TM 11-6625-316-35

**FIELD AND DEPOT MAINTENANCE MANUAL**  
**TEST SETS, ELECTRON TUBE TV-2/U,**  
**TV-2A/U, TV-2B/U, AND TV-2C/U**

CHANGE }  
No. 1 }

TM 11-6625-316-35, 8 September 1961, is changed as follows:

Figure 23. Shunt control test.

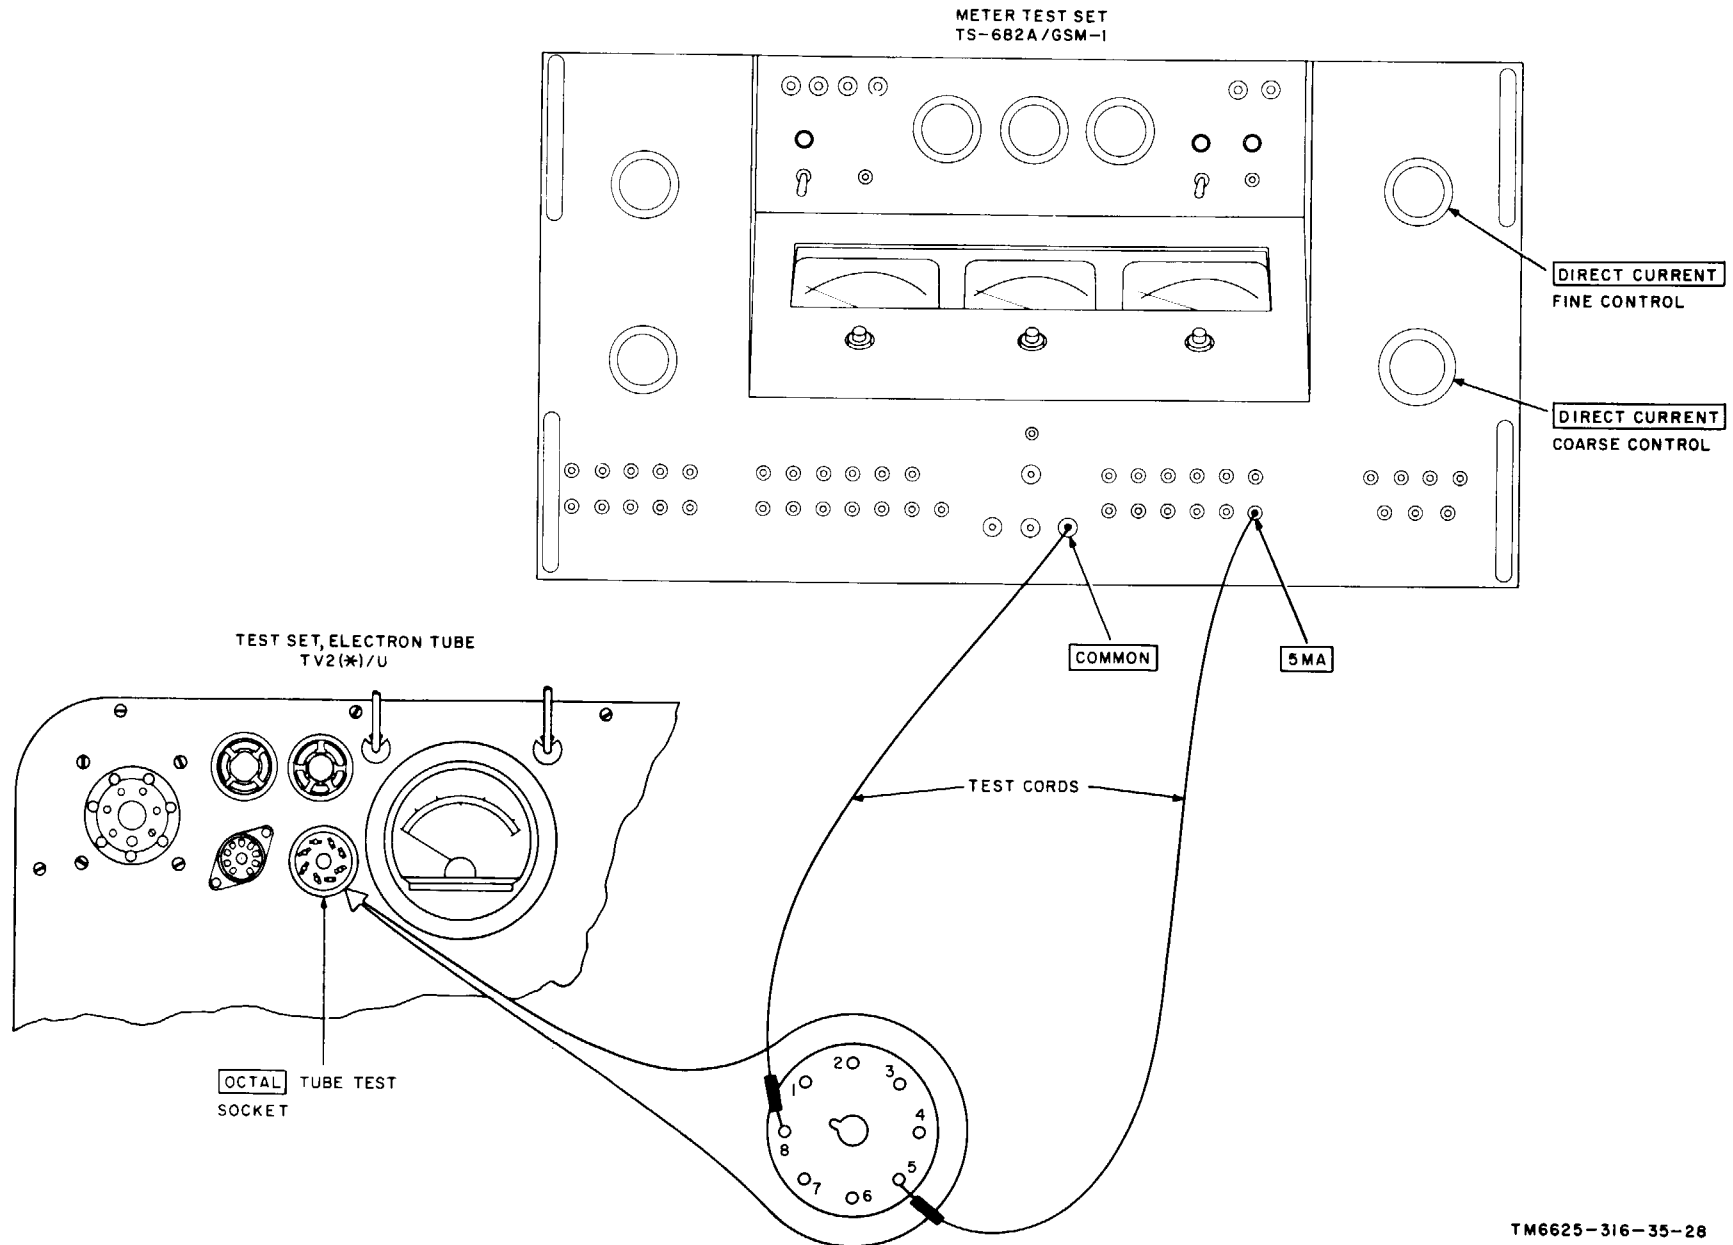
*Page 41, figure 23.* Change test leads from Meter Test Set TS-682A/GSM-1 to OCTAL tube test socket so that one test lead is from COMMON to pin 5 and one test lead is from 5 MA to pin 8.

Figure 26. Test Set, Electron Tube TV-2(VU), schematic diagram.

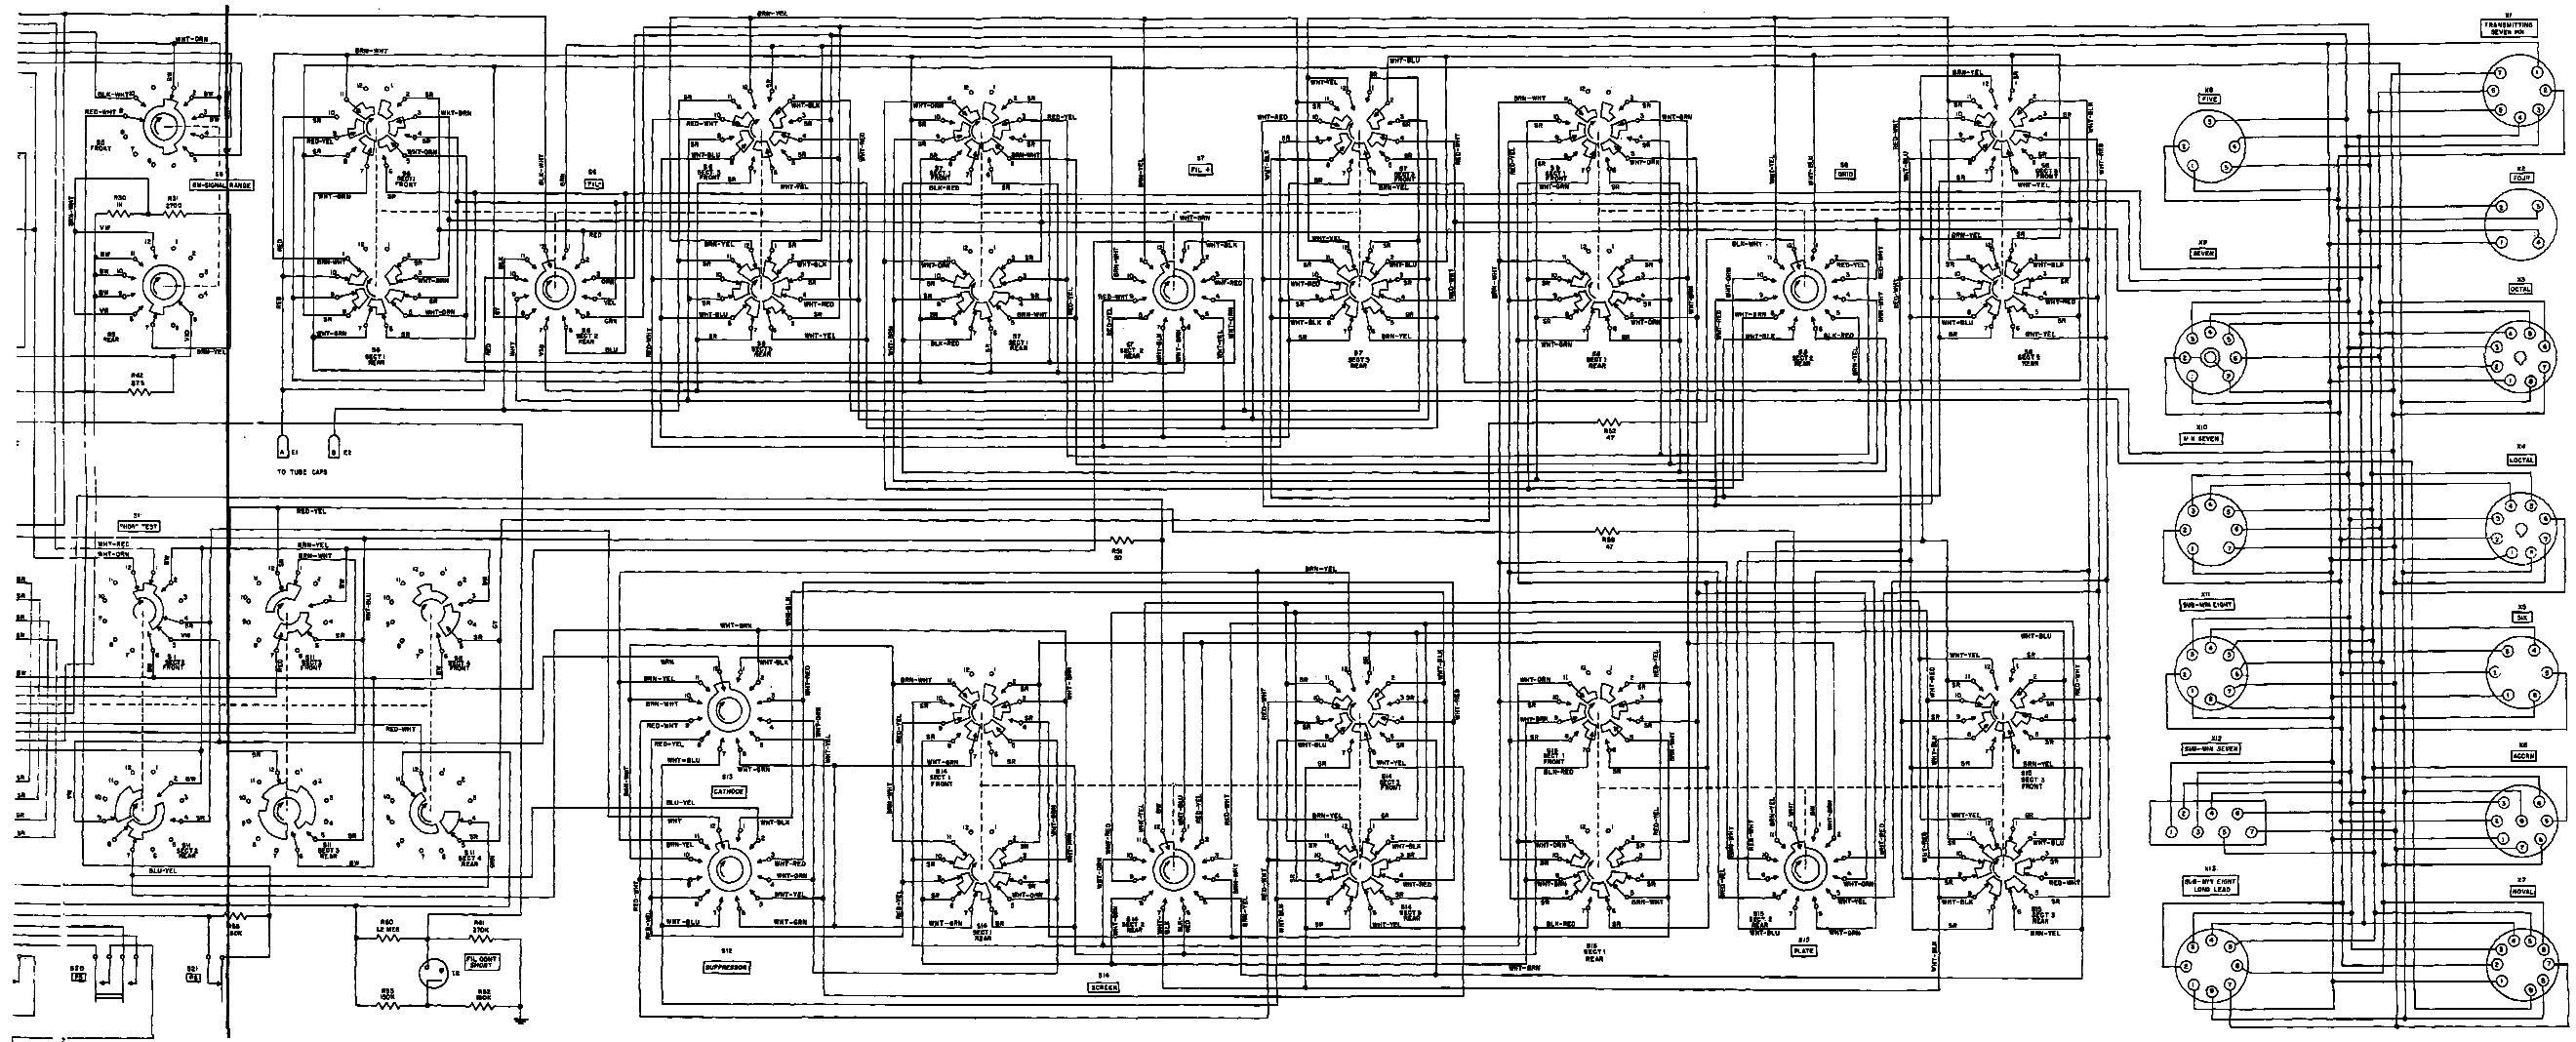
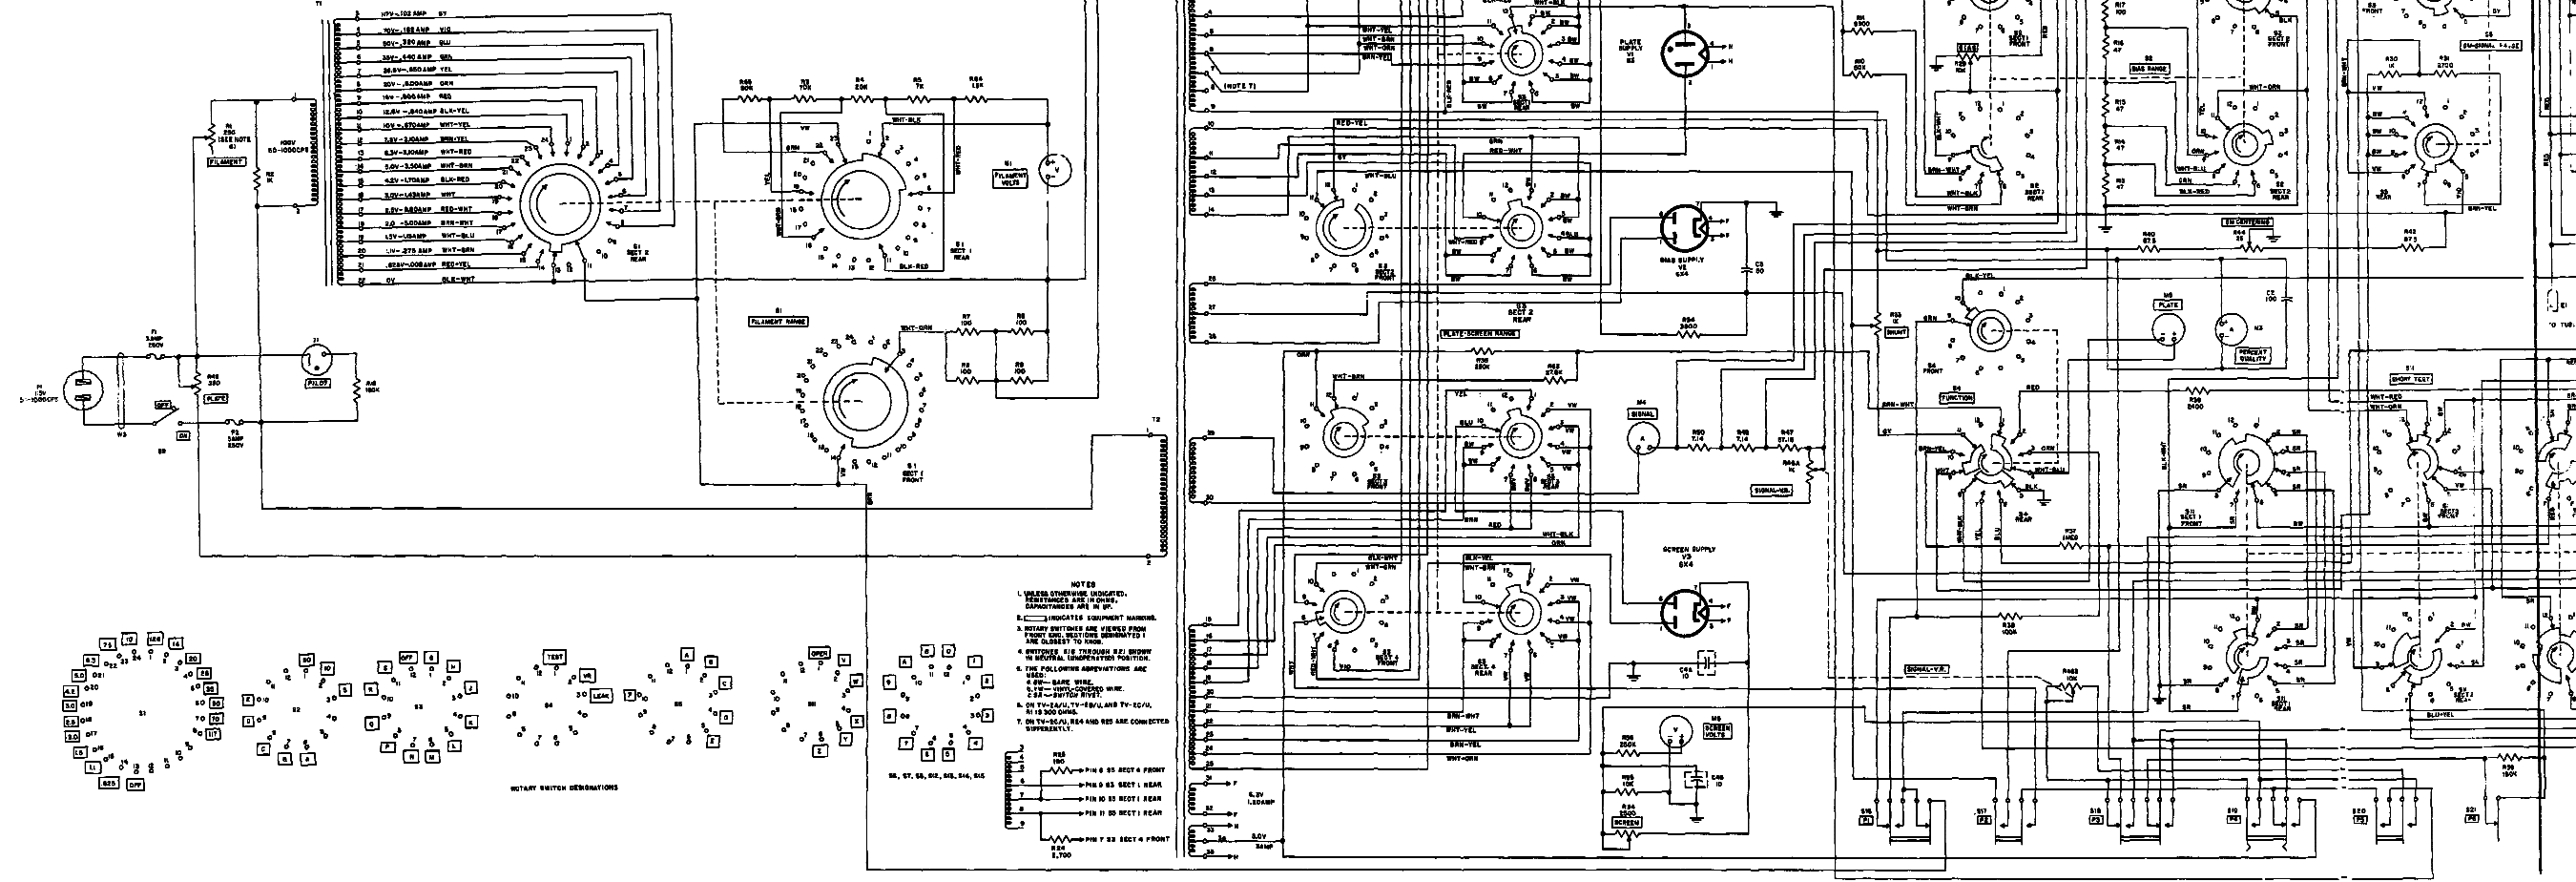
*Page 44, figure 26 (Foldout, 1st part).* In the top right corner of the illustration, on Switch S2, Section 2, front, add a connection line from Contact 11 to the upper (ungrounded) end of capacitor C 1.
